WILLOW POINTE SUBDIVISION, UNIT THREE,
RESUBDIVISION OF LOTS 100 A-F, LOTS 104 A-D, AND
LOTS 105 A-F

APPLICATION NUMBER 22 DATE February 17, 2005

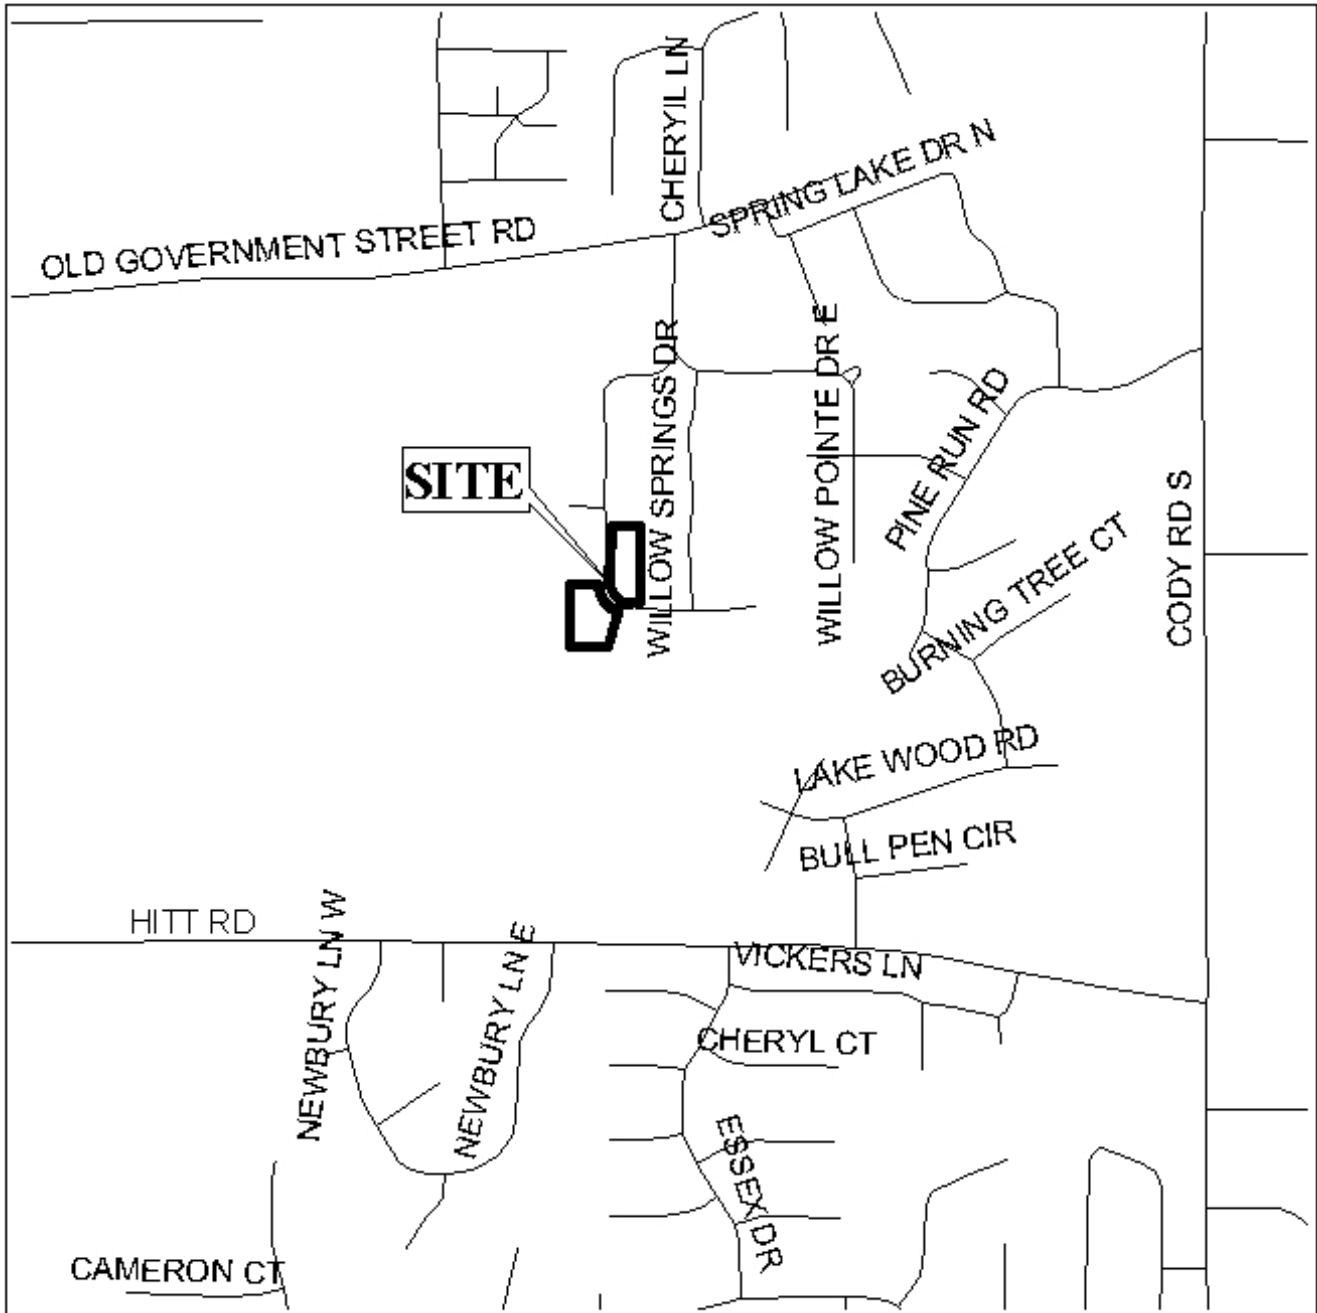
Engineering Comments: Must comply with the Mobile County Flood Damage Prevention Ordinance.

The plat illustrates the proposed 10 lot, 1.8± acre subdivision which is located at the Southwest and Northeast corners of Willow Bridge Drive West and Willow Bridge Drive South. The subdivision is served by public water and sanitary sewer.

The purpose of the application is to resubdivide 16 existing lots into 10 new lots.

This subdivision has been submitted under the “Innovative Subdivision” section of the Subdivision Regulations to allow reduced lot sizes for zero-lot line patio homes, and similar housing types in a “mixed residential use” development. The term “mixed residential use” refers to the varying sizes of residential properties within the development, ranging from townhouses, to standard size lots, to larger lots of approximately 15,000 square feet.

When the site received approval for an “Innovative Subdivision” in 1999, the Commission allowed reduced setbacks and lot widths for townhouses; with the provision of common areas and larger lots, the overall site area was sufficient for the number of lots proposed. The current proposal would retain the common areas and reduced setbacks, and create fewer, larger lots. Proposed Lots 1 through 7 would still be of substandard width and size, as they are proposed for zero-lot line patio homes; proposed Lots 8 through 10 would be substandard in width at the setback line. Therefore, a waiver of Section V.D.2 of the Subdivision Regulations, which pertains to minimum lot size and width, will be necessary. However, as common areas are being retained and the total number of lots reduced, the overall site area will remain sufficient for the number of lots proposed. Furthermore, retaining the reduced 20’ building setback will provide consistent setbacks with the portion of the subdivision already built.

With a waiver of Section V.D.2 of the Subdivision Regulations (lot size and width), the plat will meet the minimum requirements and is recommended for Tentative Approval.
